Historic District Commission

Staff Report – October 2nd, 2019

137 NORTHWEST STREET
CERTIFICATE OF APPROVAL
PUBLIC HEARING #A

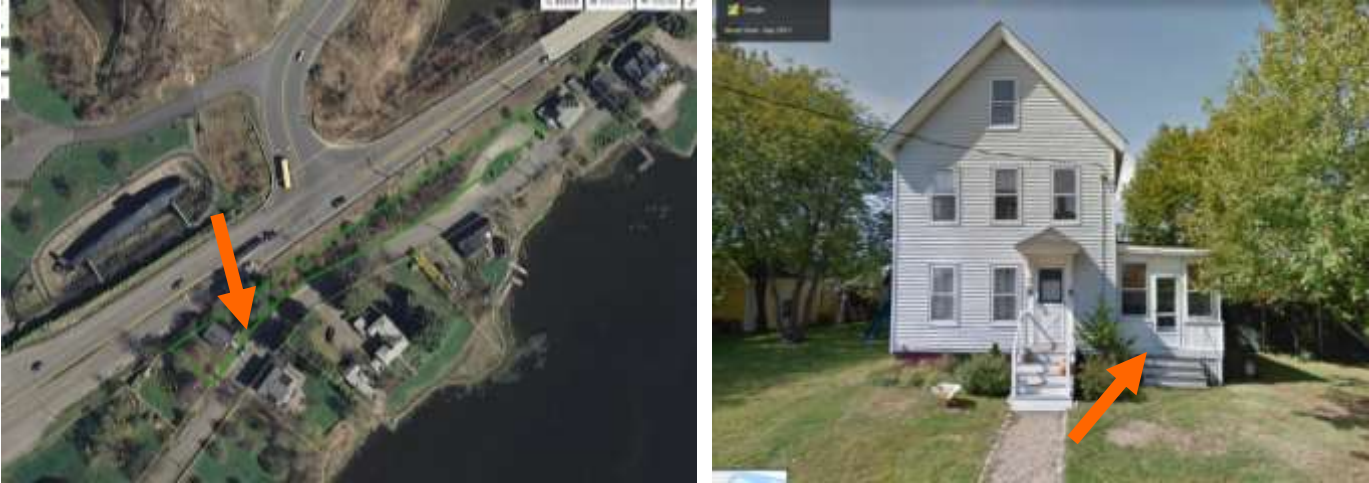
- Demolish the side porch and replace it with an open deck.
- The footprint of the deck is not being increased.
- **NOTE THAT THE APPLICANT IS SEEKING A POSTPONEMENT OF THIS APPLICATION. CONSIDERATION SHOULD BE GIVEN TO WITHDRAWING THIS APPLICATION AS ITS BEEN 5 MONTHS SINCE THE LAST WORK SESSION/ PUBLIC HEARING.**
